RE: Eagle Ranch MVD – Retail Drainage Report
Eagle Ranch Rd
Engineer's Stamp Date: 4/24/17
Hydrology File: B13D002C

SUBJECT: DRAINAGE REPORT EAGLE RANCH NM MVD – RETAIL (B13/D002C)

DRAINAGE REPORT FOR EAGLE RANCH NM MVD - RETAIL

SHEET NUMBER
C-1.0

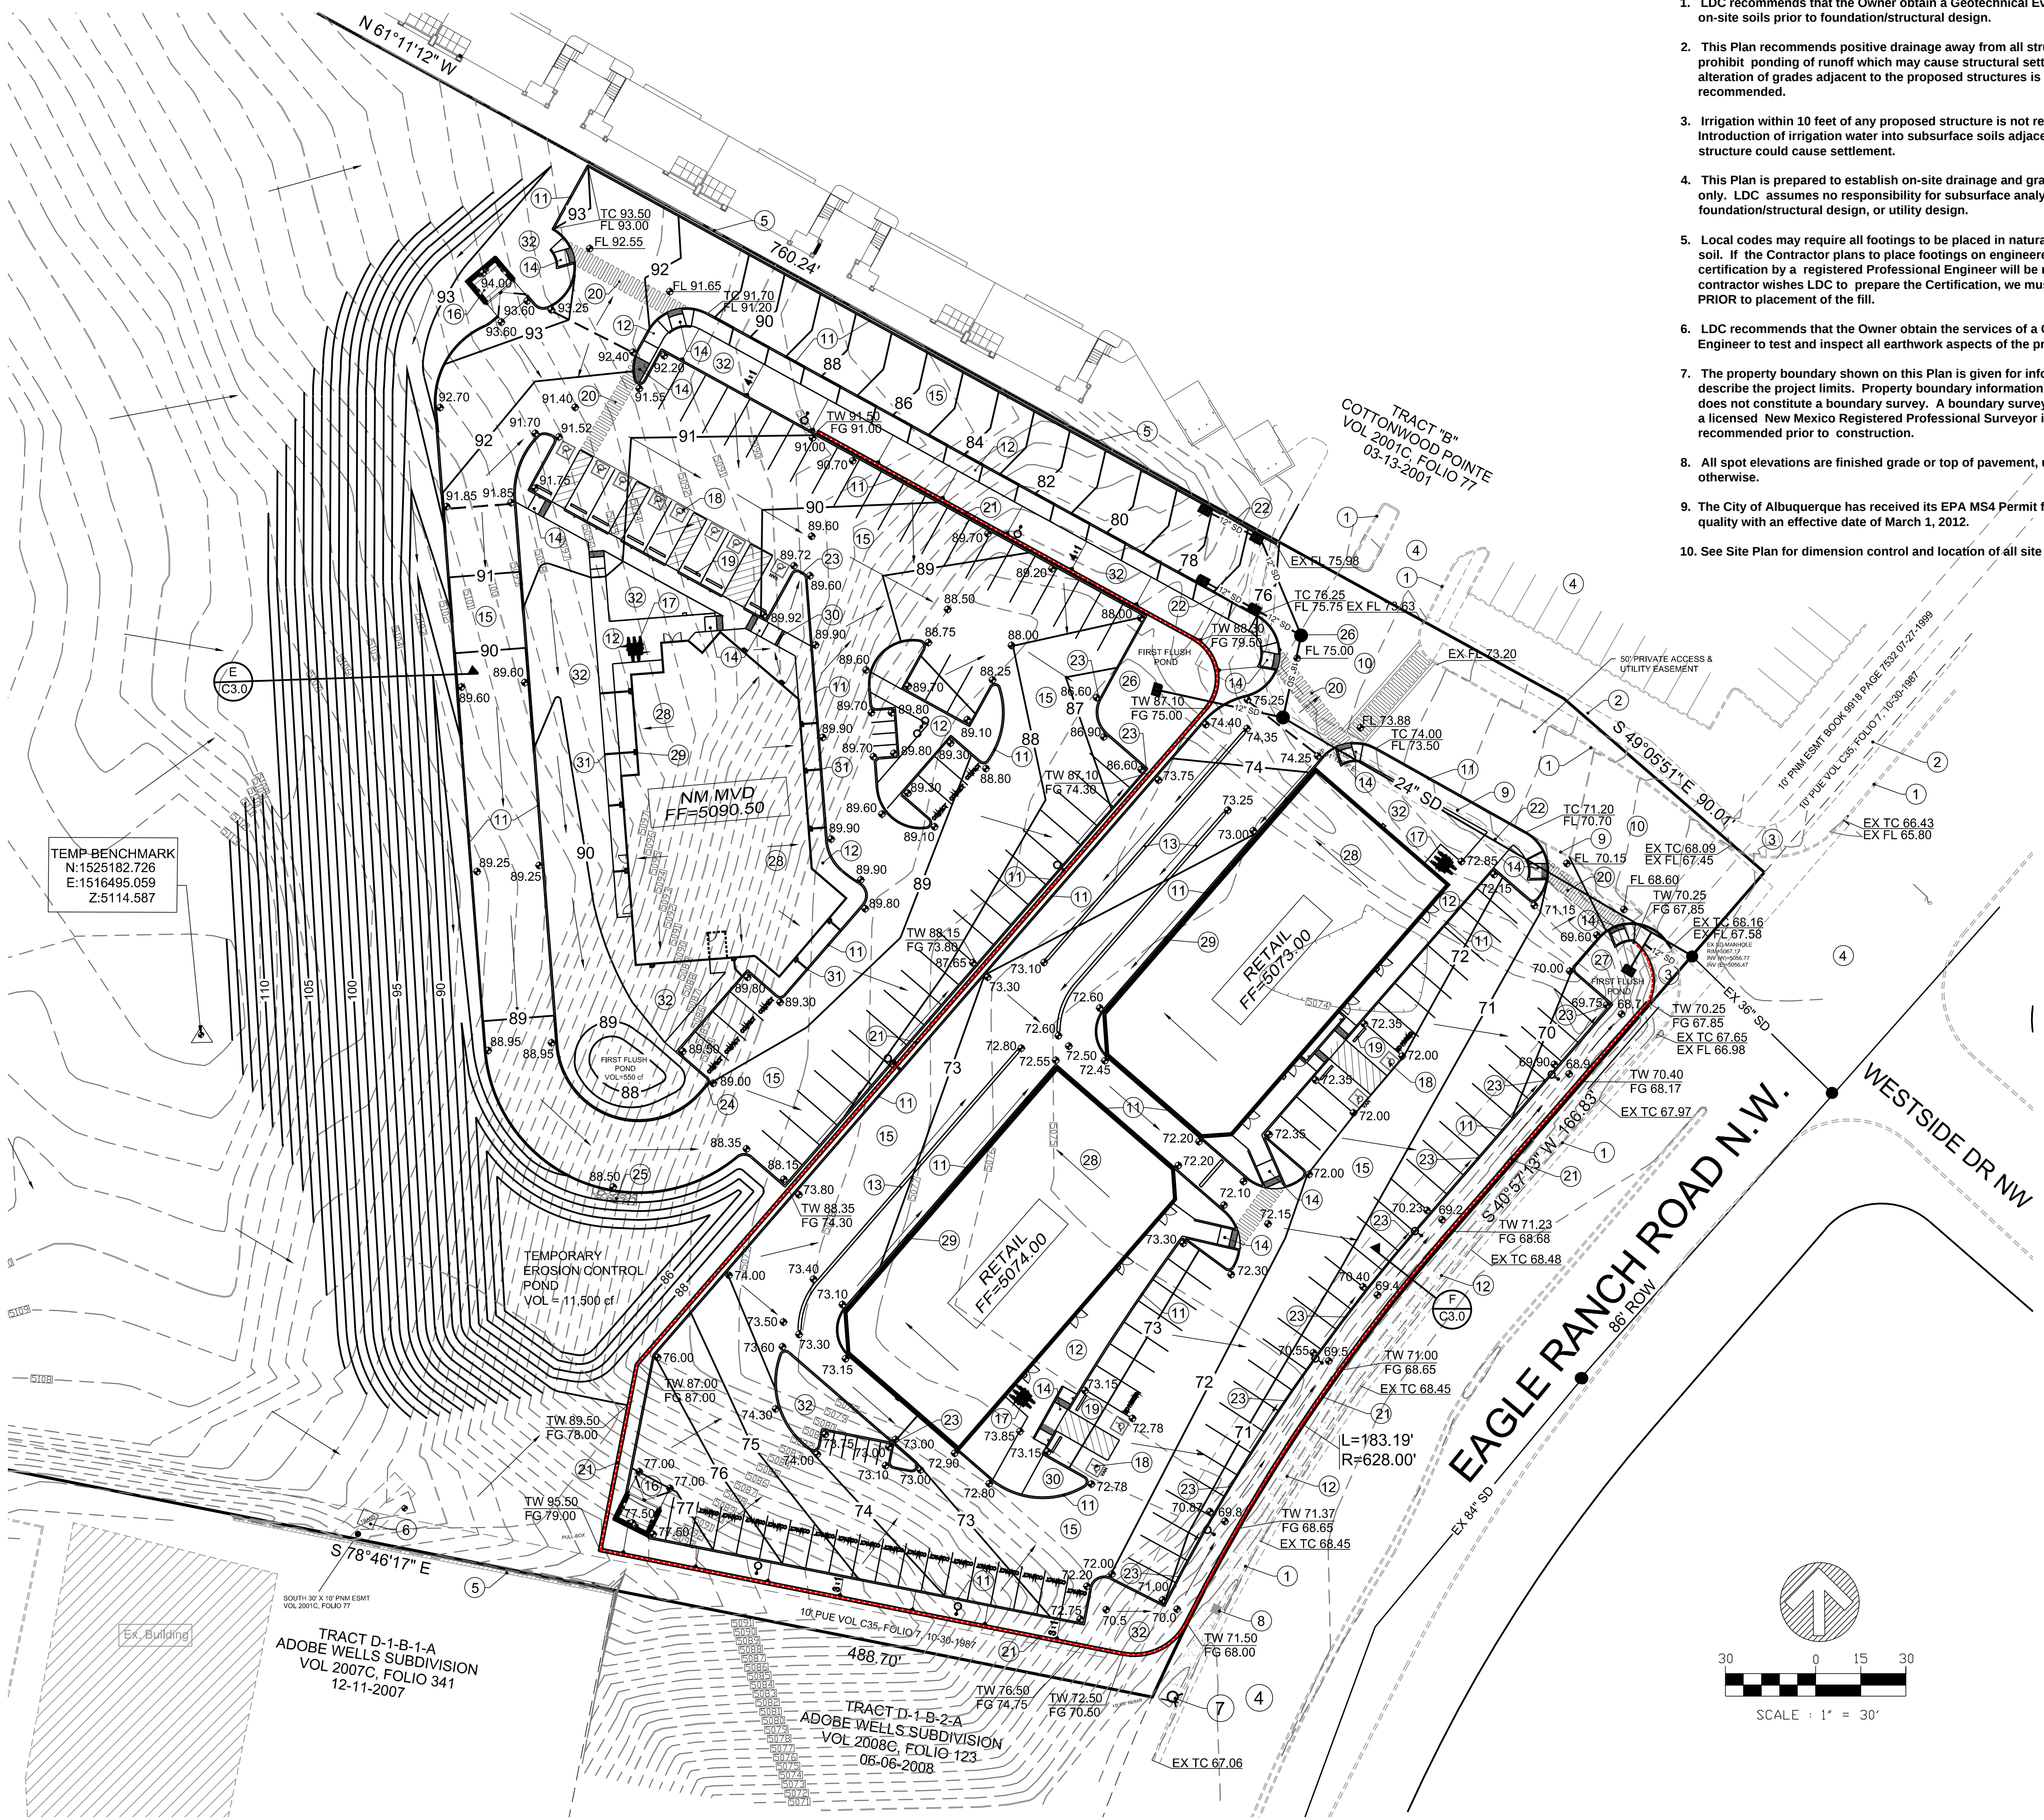
3. Detail how the connection to the storm drain stub off Eagle Ranch will be made:
- The storm drain connection cannot be made as part of the Water Utility Work Order as the City does not review Water Utility work orders.
 - The storm drain, water, and sewer connections can all be made as a City work order or mini-work order and both Water Utility and the City will review.
 - The water and sewer can remain with the Water Utility work order and the storm drain can be done by mini-work order or SO-19 permit. If SO-19 is desired, the sheets will need to include the standard SO-19 language.

Whichever route is taken, the grading and drainage sheets will need to be amended to detail how the storm drain connection is being made.
